Access Compliance Report

Public Rights-of-Way

(Curb Ramps)

Intersection ID: 23044	Main Street: CARMEL_RD	Cross Street: CROSSGATE_RD	Location: W
ADA ID: 0C19DDD9B890	Ramp Type: PerpDiag	Initial Pass/Fail: Fail	Overall Compliance: No
Severity Score: 8.75			
Codes/Mitigation Info/Possible Solution		Field Measurements/Component Compliance

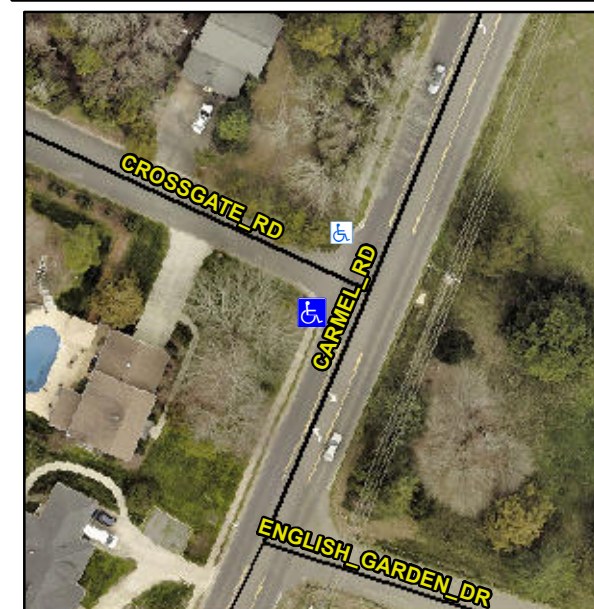
Not Found, R304.5.1

Compliance	Description	Data	Compliance	Description	Data
N/A	Ramp Length (in)	39.0	Yes	Ramp Slope (%)	7.9
No	Ramp Width (in)	47.0	Yes	Ramp XSlope (%)	0.6
N/A	Flare Type LT	N/A	N/A	Flare Type RT	N/A
N/A	Flare Slope LT (%)	N/A	N/A	Flare Slope RT (%)	N/A
N/A	Flare Traversable LT?	N/A	N/A	Flare Traversable RT?	N/A
N/A	Landing Length (in)	N/A	N/A	DWS Provided?	N/A
N/A	Landing Width (in)	N/A	N/A	DWS Contrast?	N/A
N/A	Landing Slope (%)	N/A	N/A	DWS Length (in)	N/A
N/A	Landing X Slope (%)	N/A	N/A	DWS Full Width?	N/A
N/A	Landing Curb? (Y/N)	N/A	N/A	DWS Offset (in)	N/A
N/A	Shared Landing?	N/A			
N/A	Gutter Ponding?	N/A	N/A	Gutter Slope (%)	N/A
N/A	Gutter Lip Ht (in)	N/A	N/A	Gutter X Slope (%)	N/A
N/A	Painted X Walk1?	No	N/A	Painted X Walk2?	No
	X Walk 1 Direction	To SE		X Walk 2 Direction	To NE
N/A	X Walk 1 Width (in)	N/A	N/A	X Walk 2 Width (in)	N/A
	X Walk 1 Slope (%)	3.1		X Walk 2 Slope (%)	1.8
	X Walk 1 X Slope (%)	2.1		X Walk 2 X Slope (%)	5.9

Remove & Replace Curb Ramp With Two New Directional Ramps or Equivalent.
